**NORTH
NORFOLK
DISTRICT
COUNCIL**

Norfolk Boreas Offshore Wind Farm

REPRESENTATIONS FOLLOWING EXQ2 RESPONSES SUBMITTED AT DEADLINE 4

DEADLINE 6 – 05 MARCH 2020

Access Layout

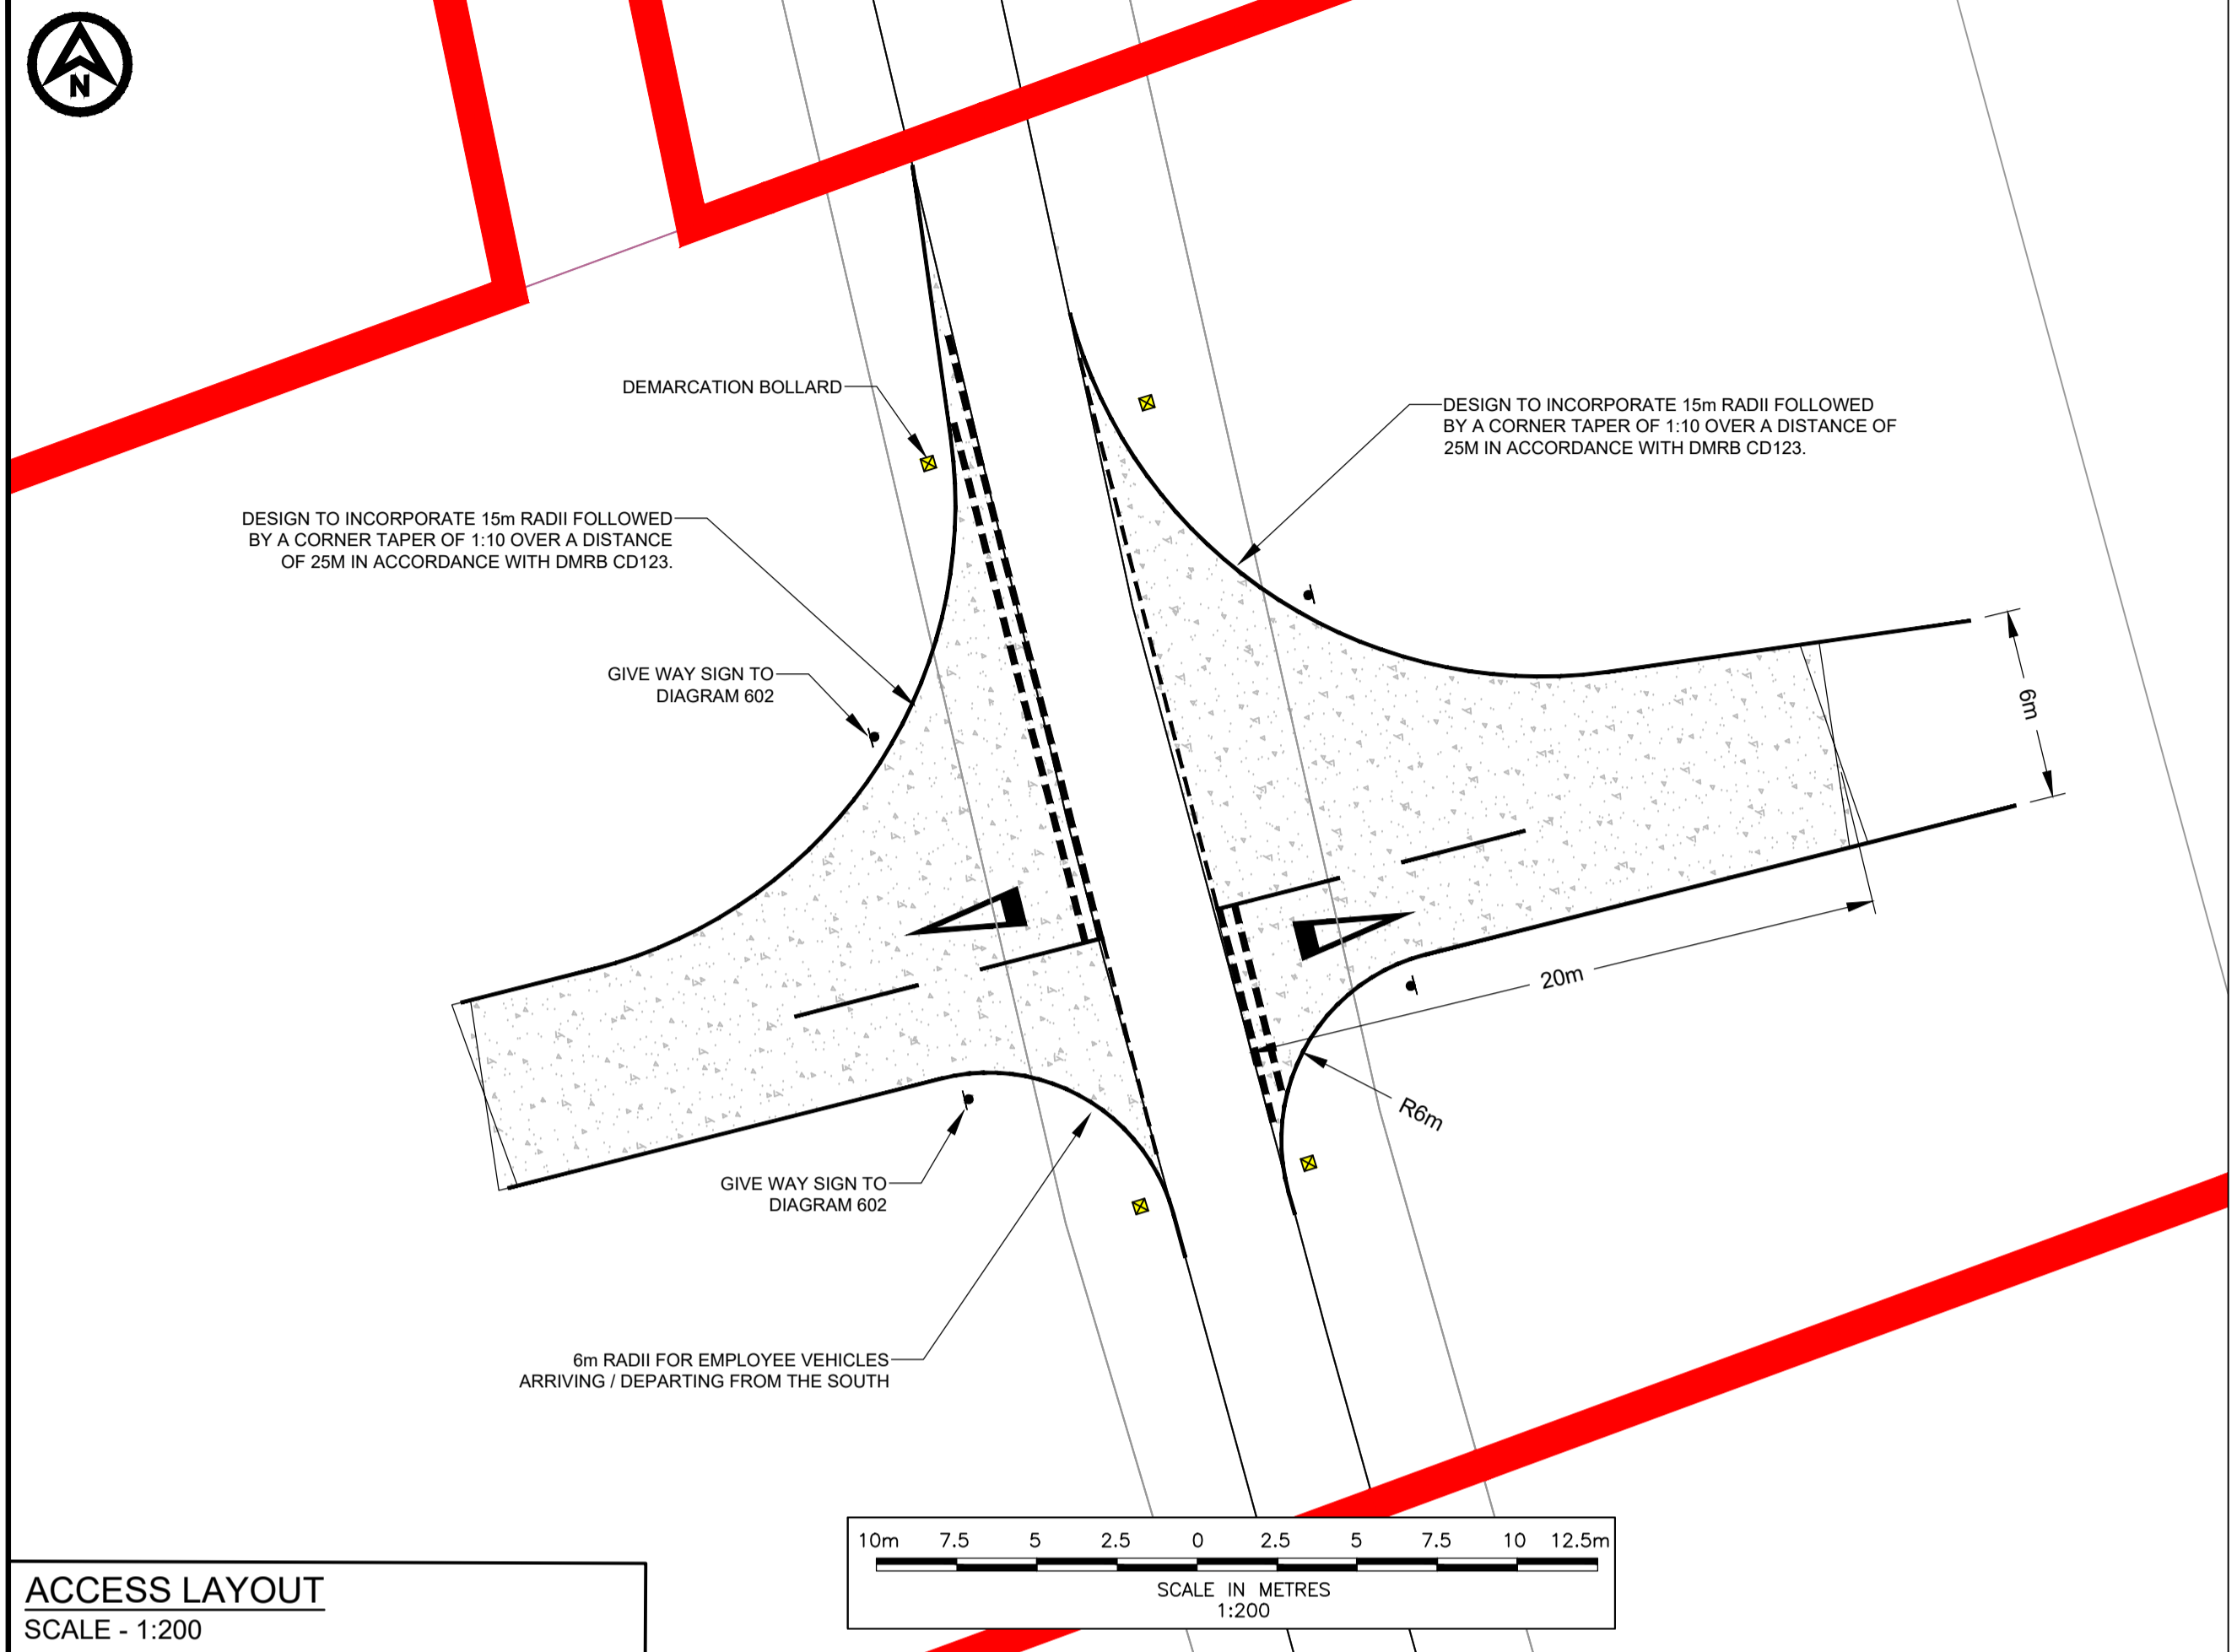
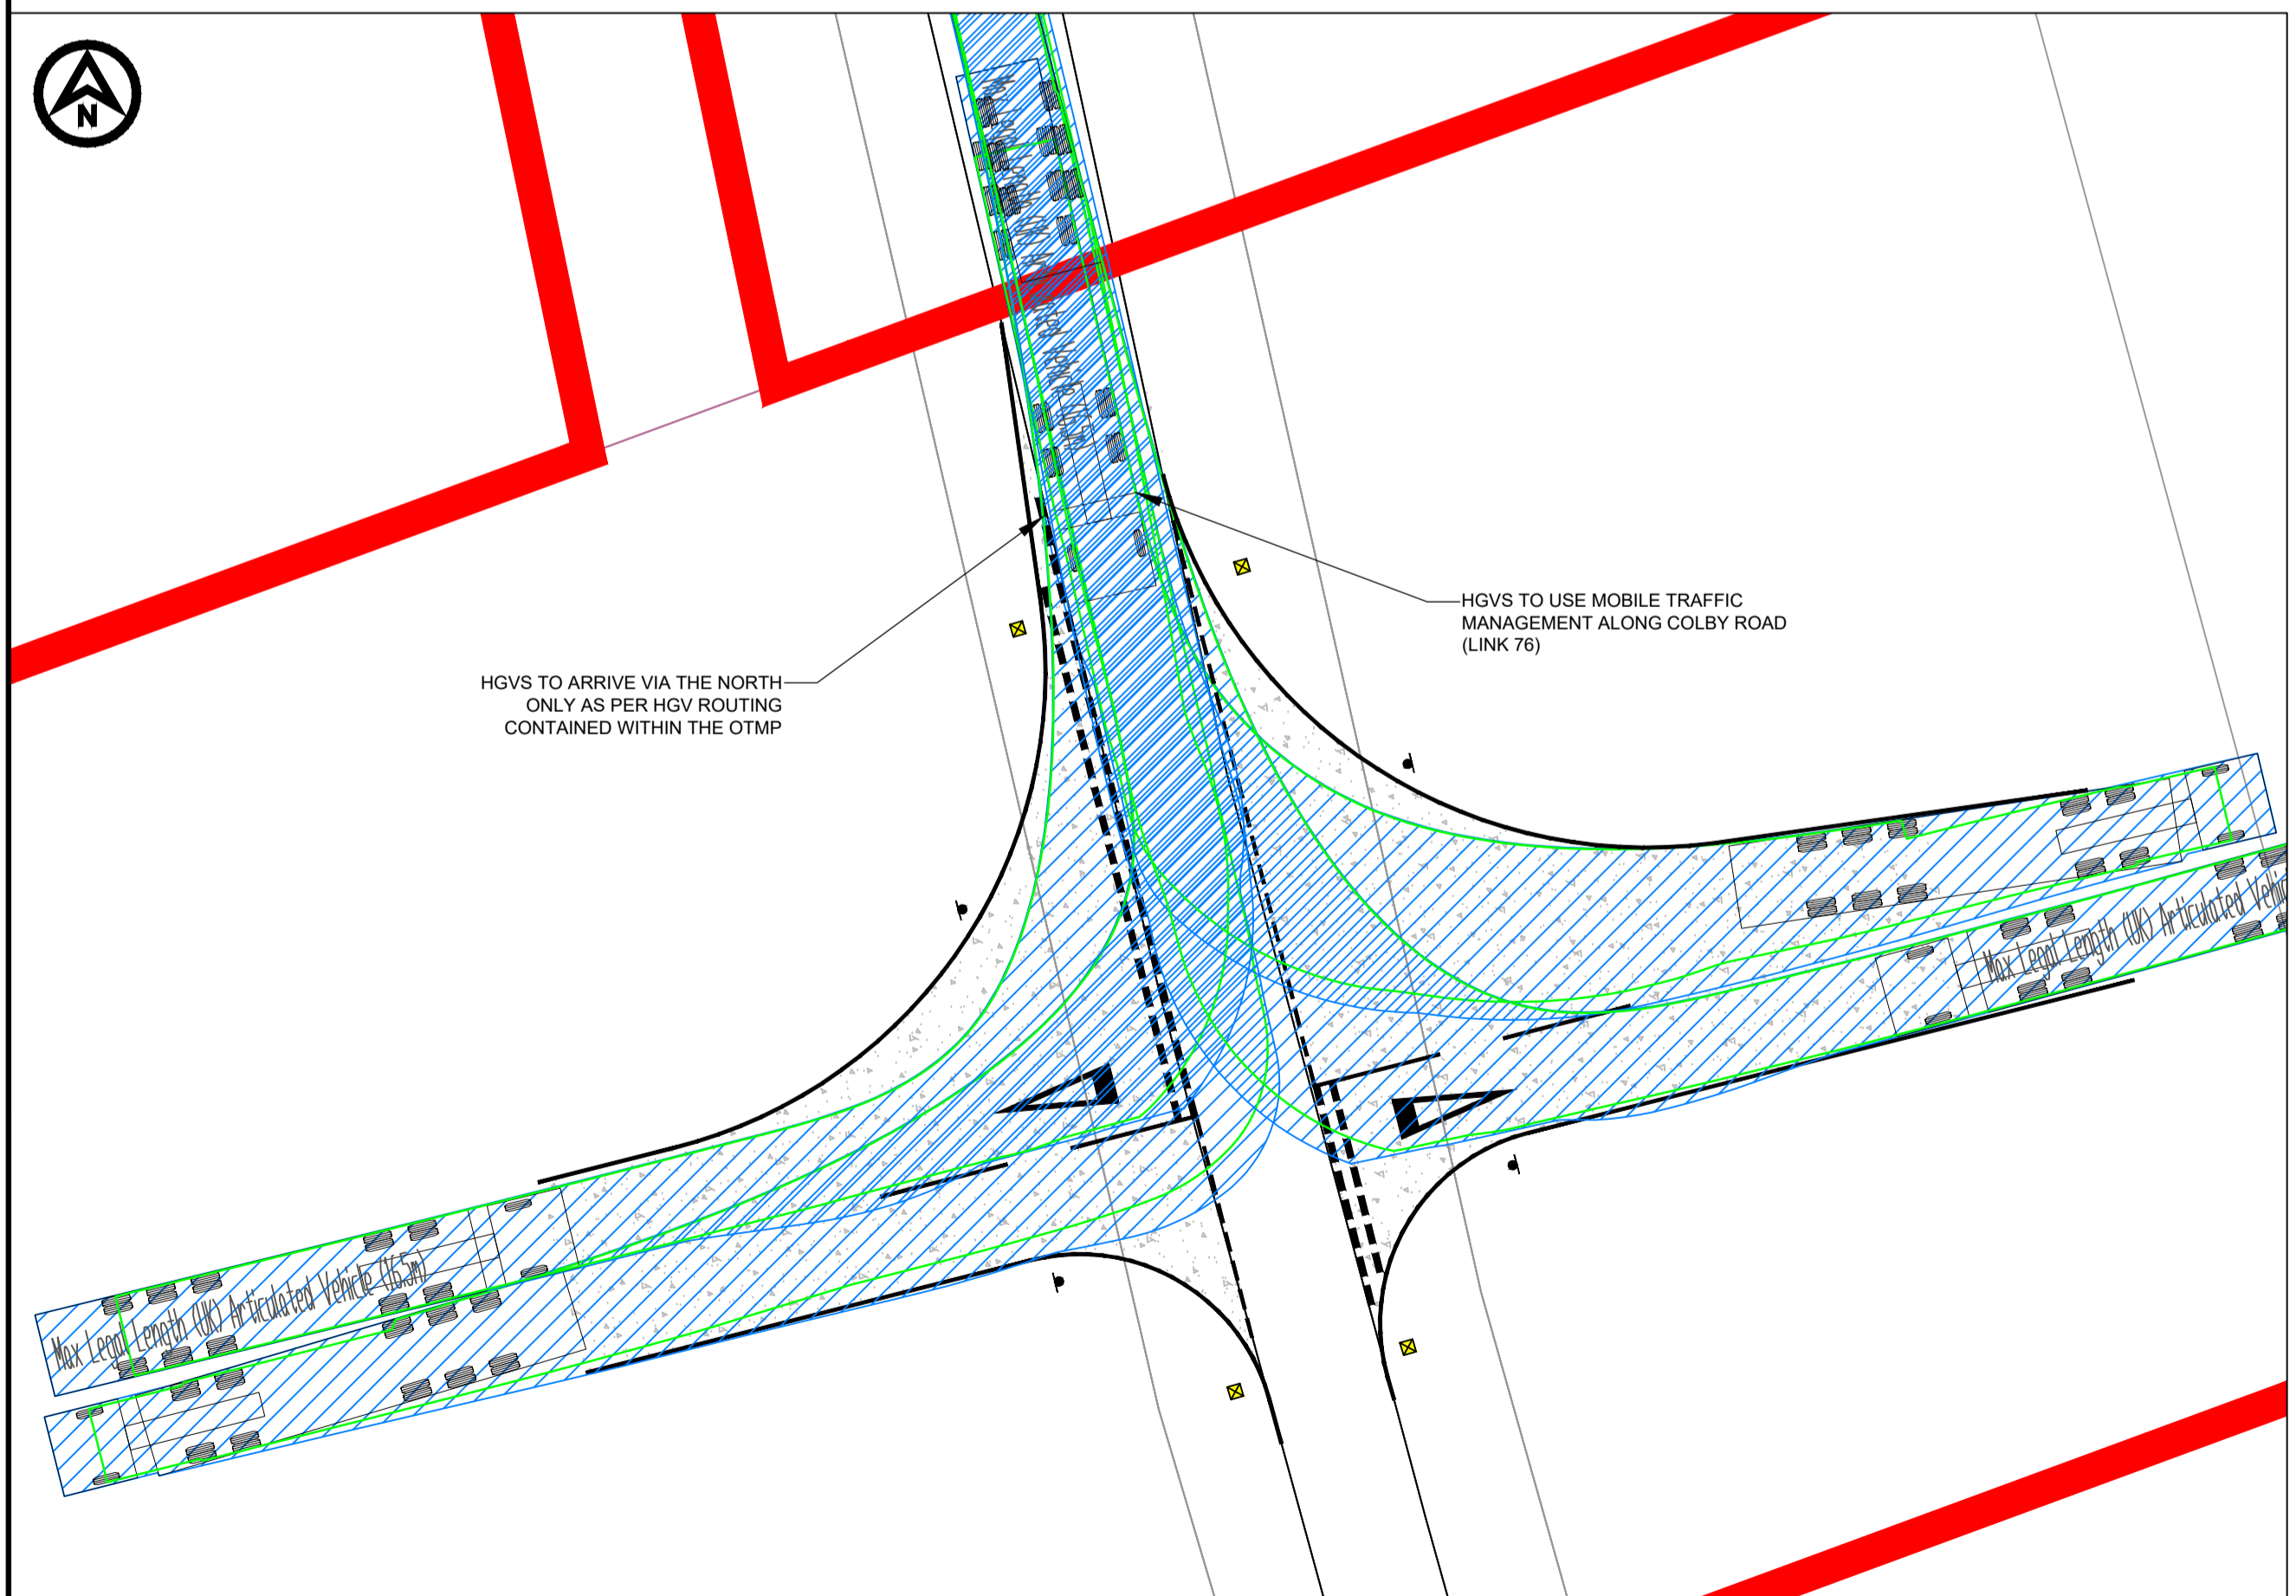
2.16. In respect of NNDC's proposed alternative solution to enable trenchless crossing under Church Road, Colby submitted at Deadline 5, following a teleconference with the applicant on 04 March 2020, NNDC understands that the applicant is considering the option presented and will provide further comment in due course.

- 2.4. In discussing this matter with the applicant, particularly with regard to alternative access points, NNDC has suggested consideration of an alternative vehicular access point to the north of the proposed cable corridor - see annotated plan of the proposal attached at **Appendix B** submitted to ExA for Norfolk Boreas at Deadline 5. This would be located at a point where there is an existing break in the tree line on the western side of Colby Road at the entrance to Hall Farm and Hall Farm Cottages. Existing access tracks could be partly used to form a new works access entrance with no loss of trees on this side of the road. On the eastern side of Colby Road, a new access could be created through the existing hedge. Whilst this may require removal of one or two semi-mature trees, the advantage of using this location is that replacement trees (and hedging) could be planted where gaps are created because the access would fall outside of the permanent easement area. These two accesses could allow new running track to be laid which will enable access to the trenchless crossing under Colby Road and thus negating the need to remove sections of three Important Hedgerows No.77, 78 and 79.
